PARKING

Survey Form 1

RESD © 2013 v.2 Access Compliance Facility Survey Checklist for State Leased Facilities

Space/Room
Item Name: Main Entrance

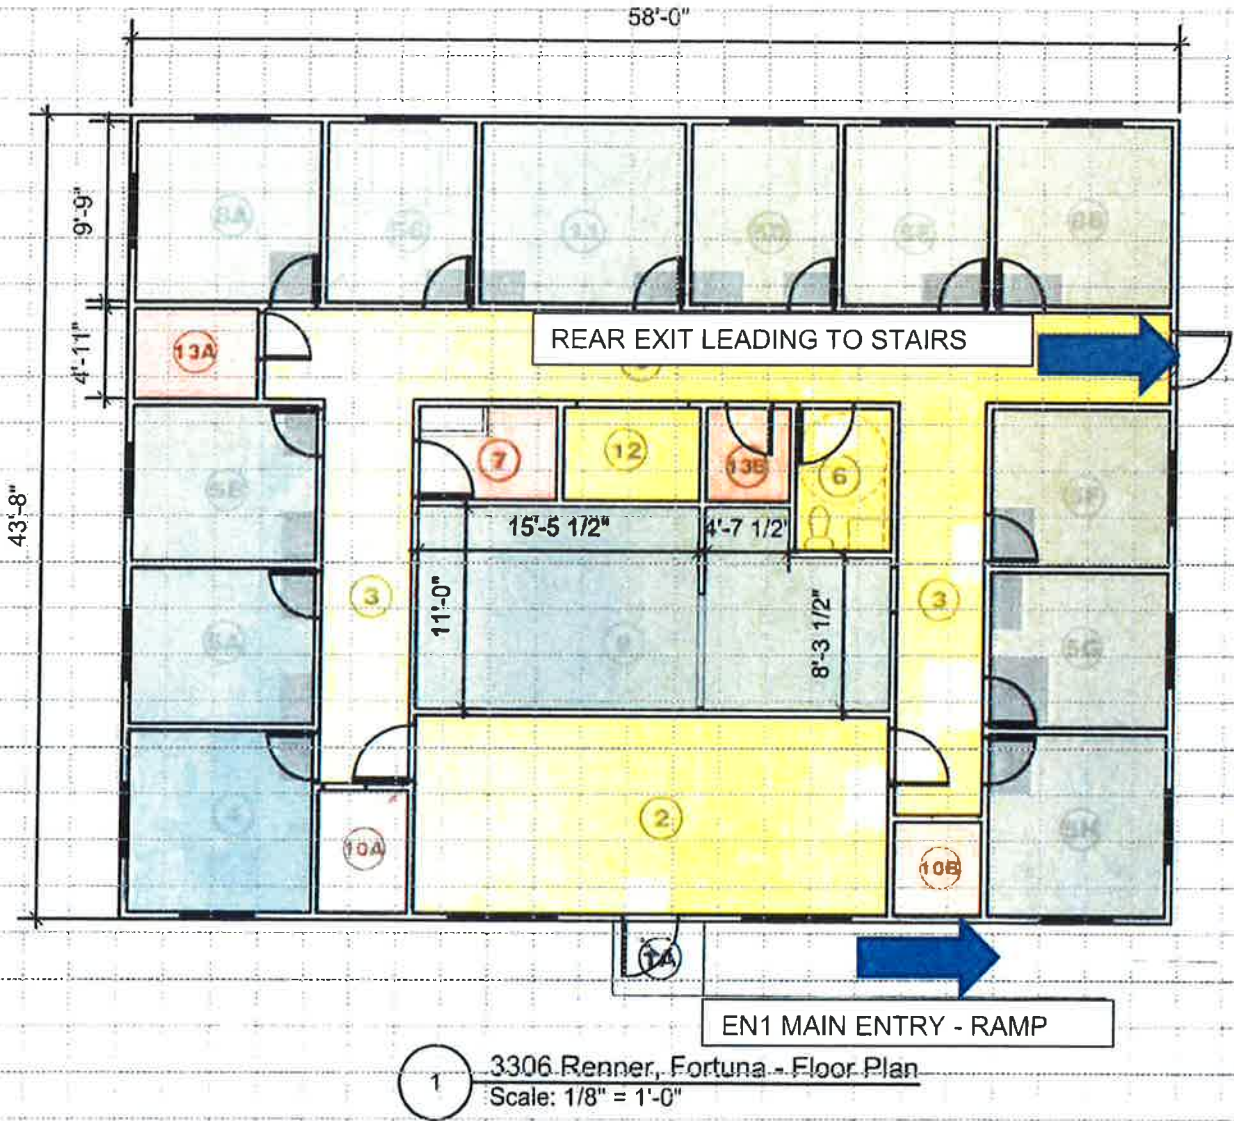
<p>* Add 12" if closer and latch are provided. ** Add 4" if closer and latch are provided. *** Beyond hinge side. **** Add 4" if closer is provided. ***** Add 6" at exterior side of exterior doors. 11B-404.2.4 Fig. 11B-404.2.4.1</p>	Approach	Side	Perpendicular to Door	Parallel to Door (beyond latch side unless noted)	Front	Pull	60"	18"*****	Front	Push	48"	0"*	Hinge	Pull	60"	36"	Hinge	Push	44"***	22"****	Latch	Pull	60"*****	24"	Latch	Push	44"*****	24"			Yes <input checked="" type="checkbox"/> No <input type="checkbox"/> N/A <input type="checkbox"/>
Approach	Side	Perpendicular to Door	Parallel to Door (beyond latch side unless noted)																														
Front	Pull	60"	18"*****																														
Front	Push	48"	0"*																														
Hinge	Pull	60"	36"																														
Hinge	Push	44"***	22"****																														
Latch	Pull	60"*****	24"																														
Latch	Push	44"*****	24"																														
10.7	Door Maneuvering Space	Is the floor level (1:48) and clear within the required maneuvering space? 11B-404.2.4.4			Yes <input checked="" type="checkbox"/> No <input type="checkbox"/> N/A <input type="checkbox"/>																												
10.8	Kick Plate	Does the bottom 10" of all doors except automatic and sliding have a smooth, uninterrupted surface on the push side to allow the door to be opened by a wheelchair footrest without creating a trap or hazardous condition? 11B-404.2.10	Door stop needs to be removed.		Yes <input type="checkbox"/> No <input checked="" type="checkbox"/> N/A <input type="checkbox"/>
